# INITIAL FIRE SAFETY INSPECTION REPORT

## Nofs Garments Ltd.

Date: 14 August 2022

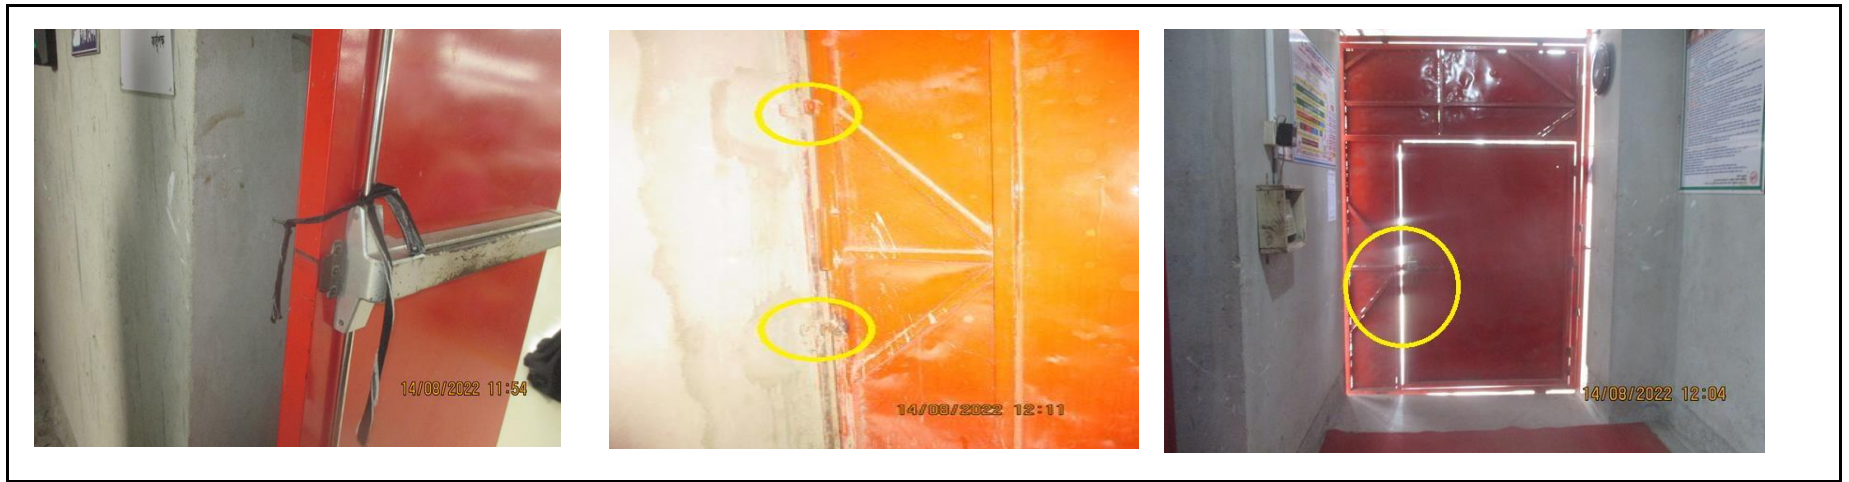
F-7	Fire Rated Construction	<p>The exit discharge path was not fire separated with production floor. The passageway for stair-2 and egress court for stair-1 were not properly fire rated. The egress court was only 36 inch wide where unprotected openings within 10 ft height were available with production building.</p>	<p>Ensure that the passageway is fire rated by 2-hour including protection of unprotected opening by minimum 1.5 hour. An egress court serving as a portion of the exit discharge shall be open to the sky or provided with a fire resistance rated enclosure the same as the exit enclosure. Egress courts less than 3050 mm (10 ft) in width (as measured from the building and the adjacent property line) shall be provided with walls having a 1-hr fire resistance rated construction for a distance of 3050 mm (10 ft) above the floor of the court.</p>	Within 3 Months
-----	-------------------------	---	---	-----------------
